**Leicestershire County Council:
North and East Melton
Mowbray Distributor Road
(MMDR)**

Stage 1 Road Safety Audit

Job No: 60542201.M001.RSA Reference: 60542201/M001/RSA/RSA1/02 Date Created: 21st December 2018

SHEET TITLE ROUTE PLAN SHEET 2 OF 3

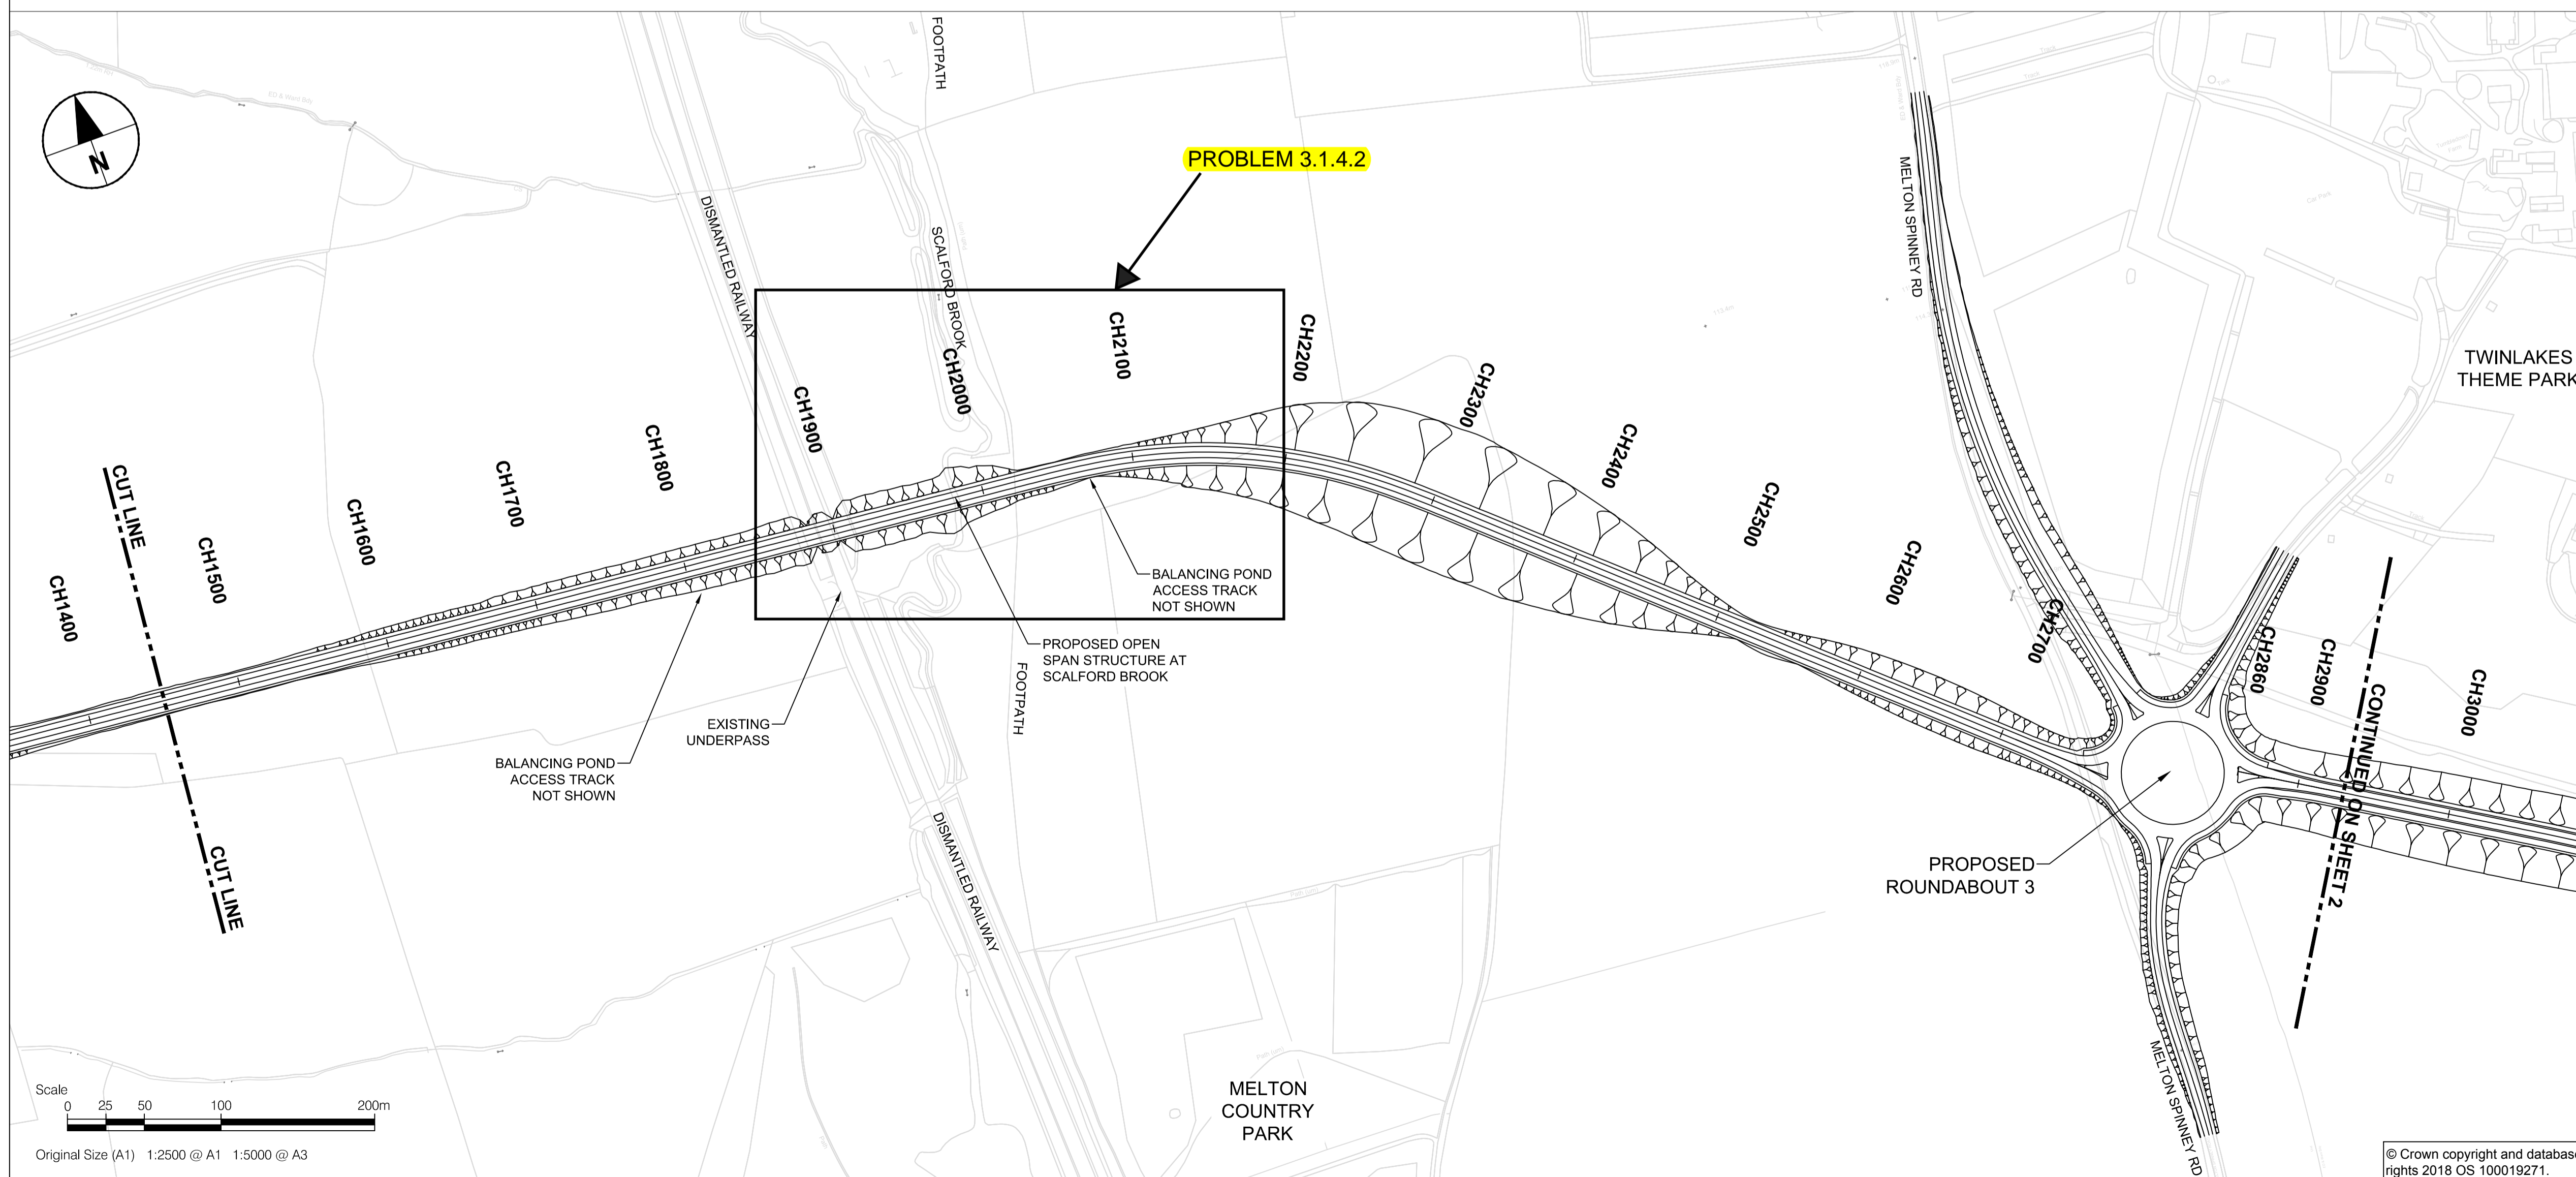
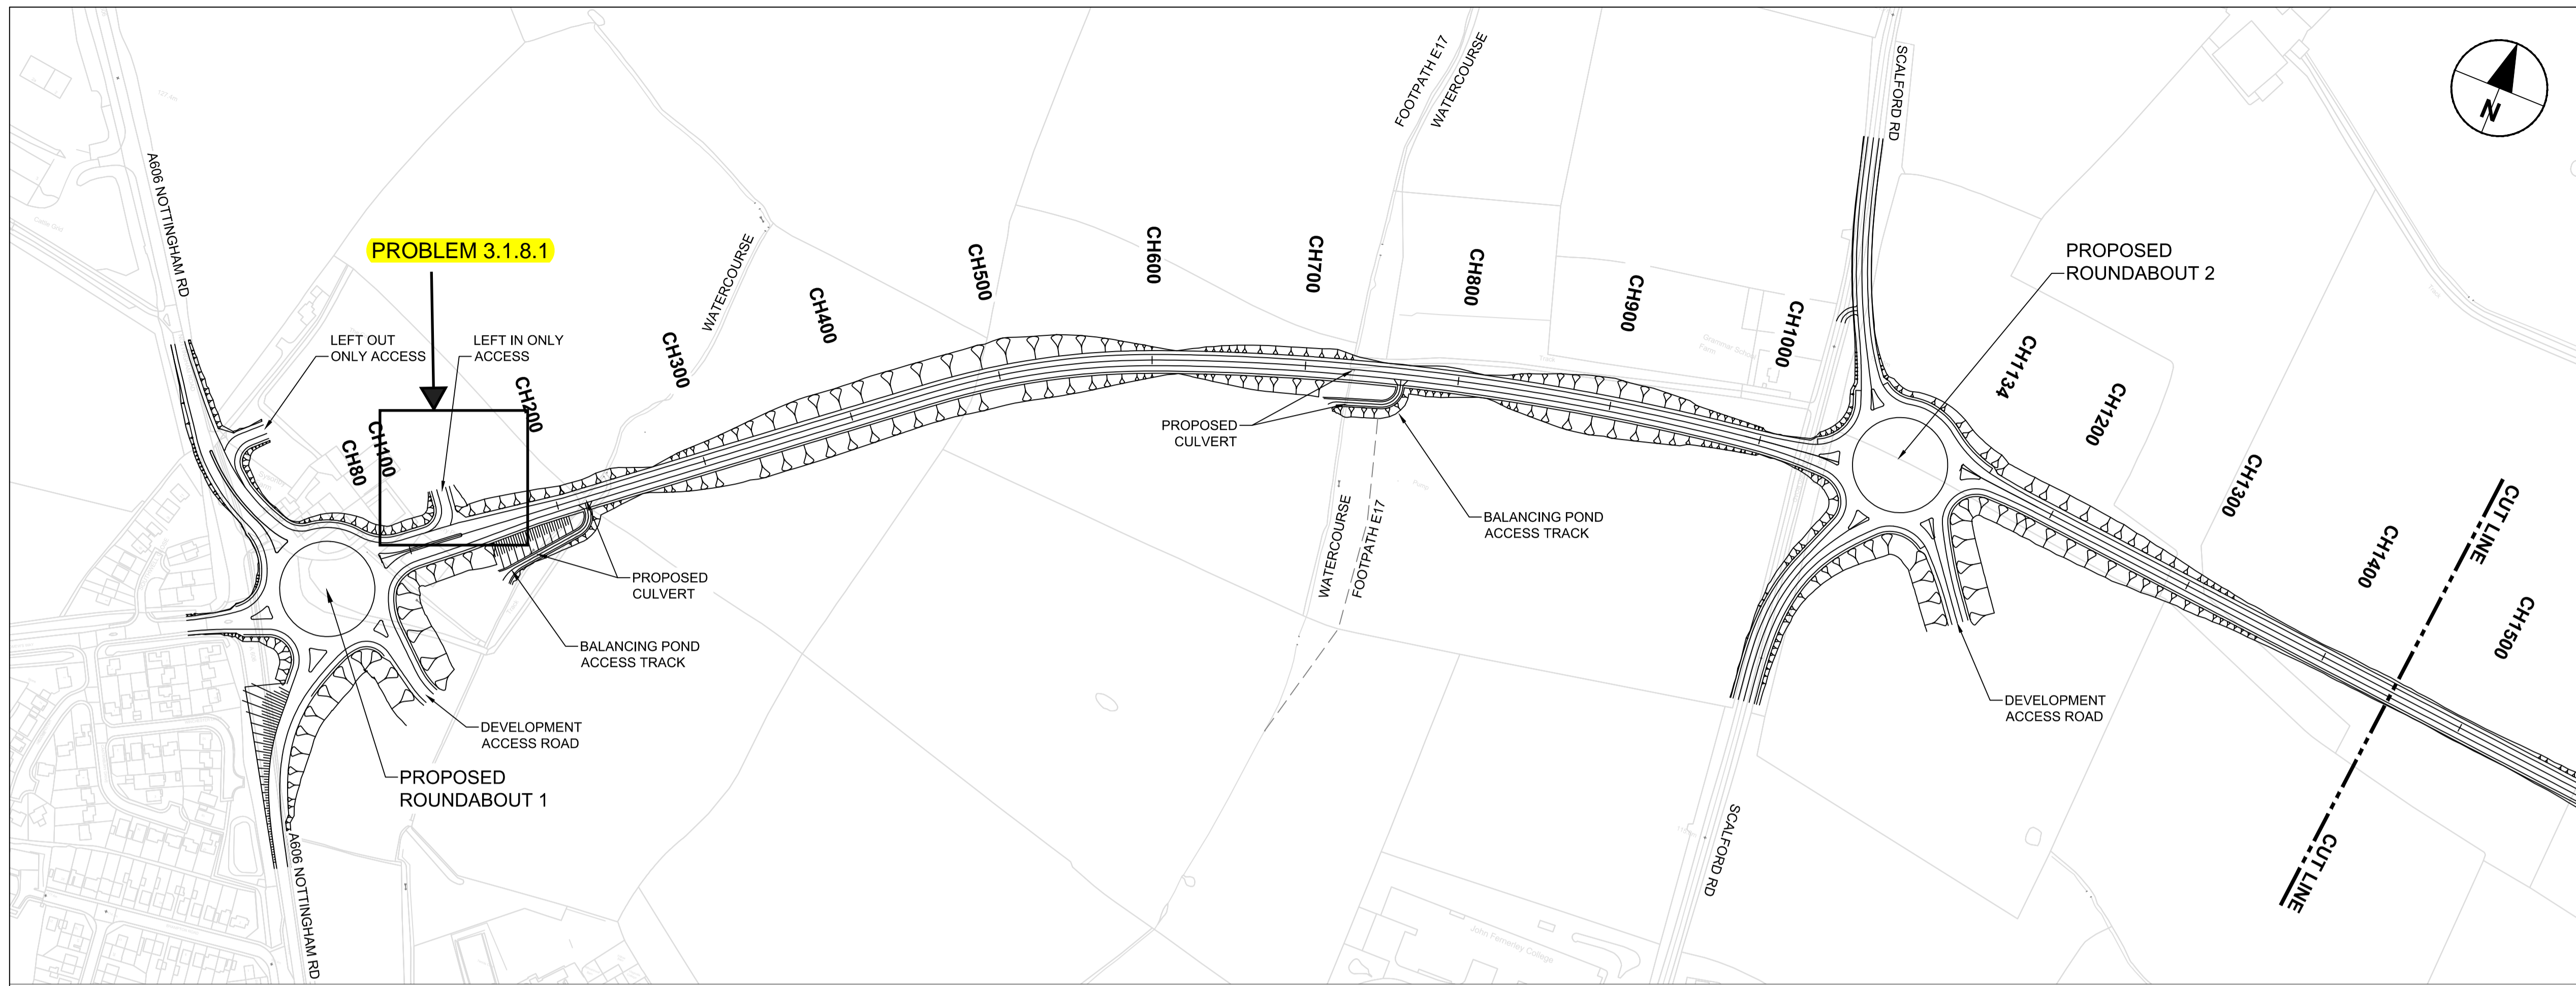
Drawing No(s): 60542201-ACM-HGN-GEN_ZZ_Z-SK-CH-0010 P01.

Location: Mainline section between roundabouts 3 and 4.

Summary: Proposed speed limit between roundabouts may lead to late braking and shunt type collisions occurring due to short section of carriageway.

There is a proposed 60mph speed limit between roundabout 3 and roundabout 4 which is approximately 700m in length; prior to roundabout 3, the speed limit along the MMDR is 40mph. There are concerns that due to this relatively short section of carriageway and the fact there are two proposed balancing pond accesses between roundabout 3 and roundabout 4, the change in speed limit may lead to shunt type collisions with vehicles approaching the roundabouts too quickly or leaving the MMDR to access the balancing pond access tracks.

It is recommended that a review of the 60mph speed limit between roundabouts 3 and 4 is undertaken and consideration to reducing the speed limit to 40mph is considered at detail design.

Both the roundabout approaches and the access tracks will be designed with the appropriate stopping sight distance visibility on approach, giving motorists adequate time to react and slow down. In addition, access will be required to the balancing pond access tracks on a very occasional basis by appropriately equipped vehicles. Although the relatively short distance between the roundabouts may result in lower 85th percentile speeds along this section this would not result in a significant safety hazard or justify a reduction in the speed limit.

SHEET TITLE ROUTE PLAN SHEET 1 OF 3

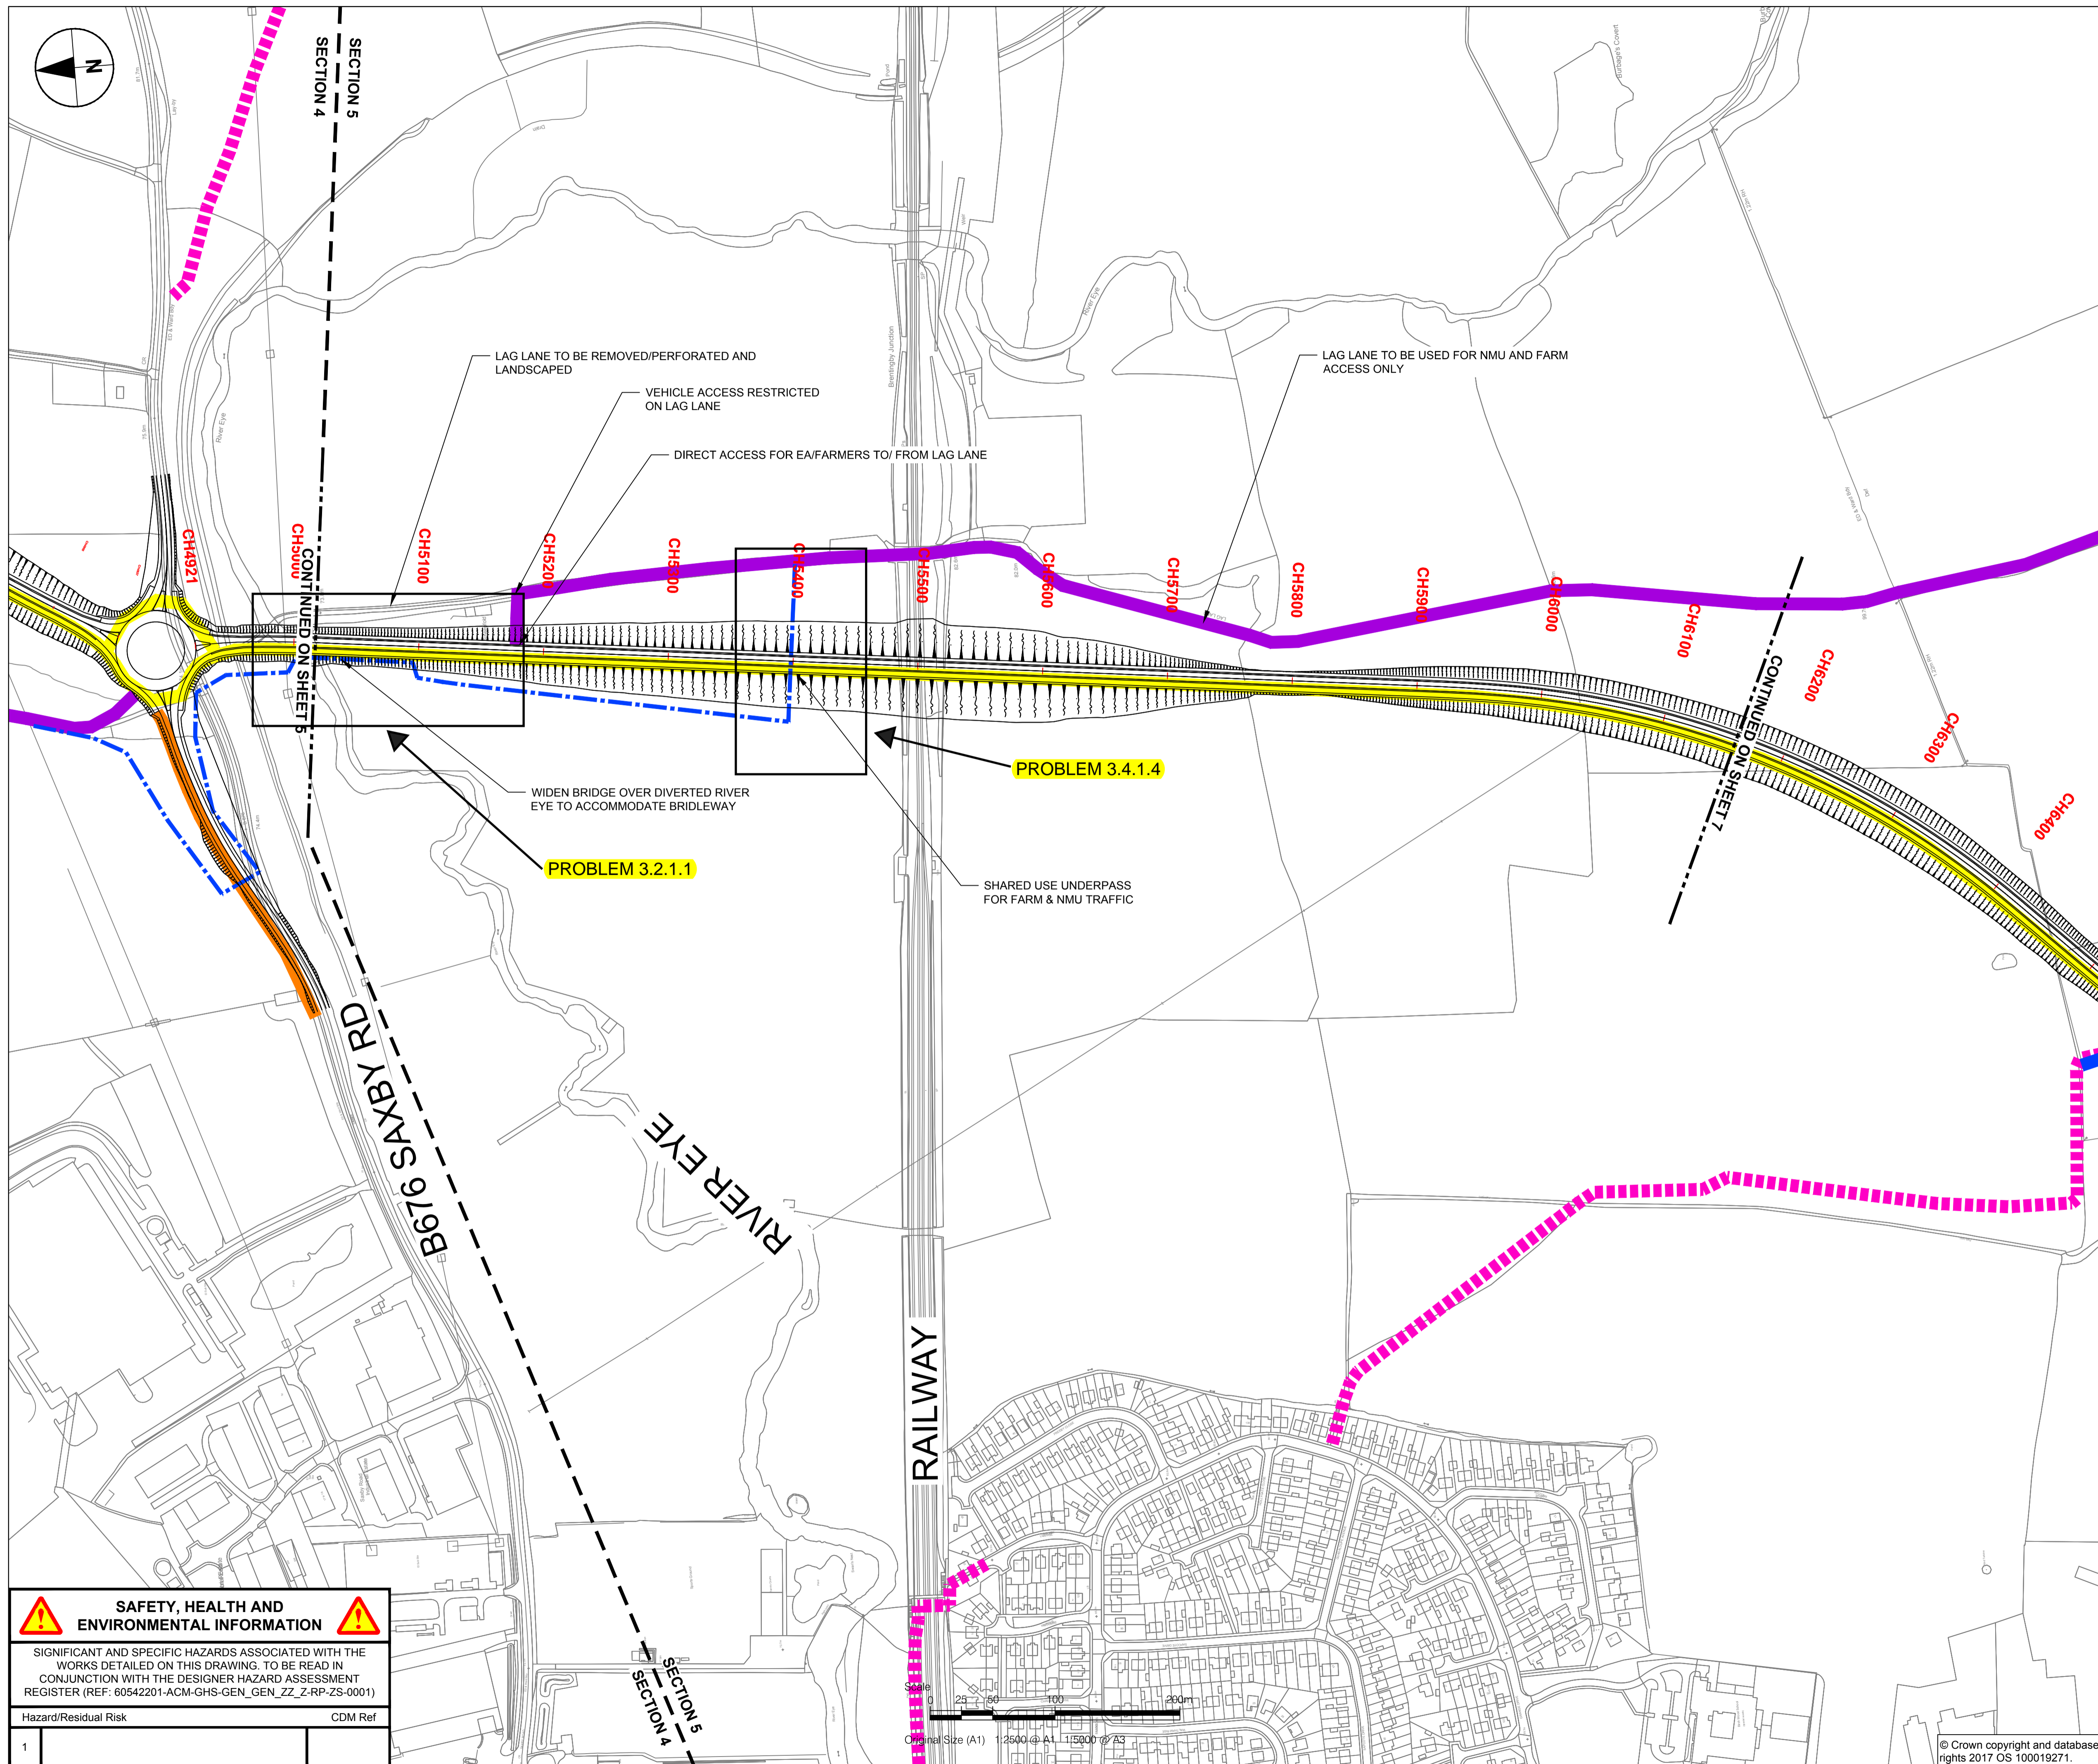
Drawing Number(s): 60542201-ACM-HGN-GEN_GEN_ZZ_Z-SK-CH-0009 P01.

Location: Left in only access adjacent to roundabout 1.

Summary: Proposed access location potentially increasing the likelihood of shunt type collisions with following vehicles due to late or sudden braking and turning manoeuvres.

There are concerns that the proposed 'left in only' access located at approximate CH125m is positioned too close to the MMDR roundabout exit arm. It is unclear at this stage what the access is intended to be used for. Drivers leaving the roundabout onto the MMDR exit may not be expecting vehicles in front to brake in order to leave the carriageway, increasing the likelihood of shunt type collisions with following vehicles.

It is recommended that the 'left in only' access is relocated onto the A606 Nottingham Road northern arm of roundabout 1; access/egress should be provided at the same location.

The RSA recommendation to co-locate the access / egress on the northern arm of Roundabout 1 would require vehicles to execute right-turning manoeuvres across traffic flow, on the A606, which is likely to increase the risk of vehicular conflict when compared with the proposed left-in / left-out arrangement. The left-in / left-out access and egress adjacent to roundabout 1 is for a proposed LCC highway maintenance depot and its position will be reviewed against the design standards and appropriate signage provided to minimise the risk of unexpected manoeuvres and vehicular conflict. The left-in / left-out arrangement is currently considered to provide the safest option for access to / egress from the proposed depot.
